Project:	Tear Drop Park Deck Wood Repair	r Date:	February 13, 2013	
Engineer:	Ensign Engineer	RE: # of Pages:	Addenda #1 2	
The following revisions and/or clarifications are to be made to the proposal documents for Tear Drop Park Deck Wood Repair". They are a result of issues discussed at the pre-proposal conference held on February 5, 2013 and any questions received by close of business of February 8, 2013 Clarifications:

ATTACHMENT TO CONCRETE BASE/STRINGER DETAIL

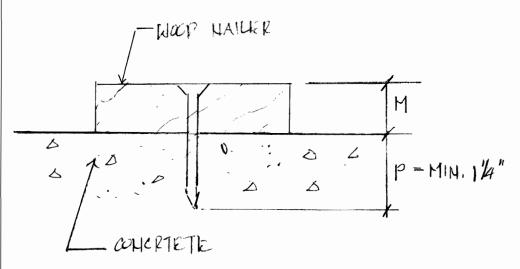
- HOOD HALLER TO L'ONCILETE.
- Z. SCREWS ARE TO 14" HOT-DIPPEID GALVANIZED WITH A MIH. EMBEDMENT OF 14"4 MAX. EN BEDMENT OF 134."
- 3-CONTRACTOR TO SELECT SCREW LENGTH BASED ON THICKNESS
- 4- SCRIEN SPACHIE SHALL 2 ROWS E"C. C TO ALLOW A STRUCTURALLY SOUND BASIC TO HAIL 1PE TO.
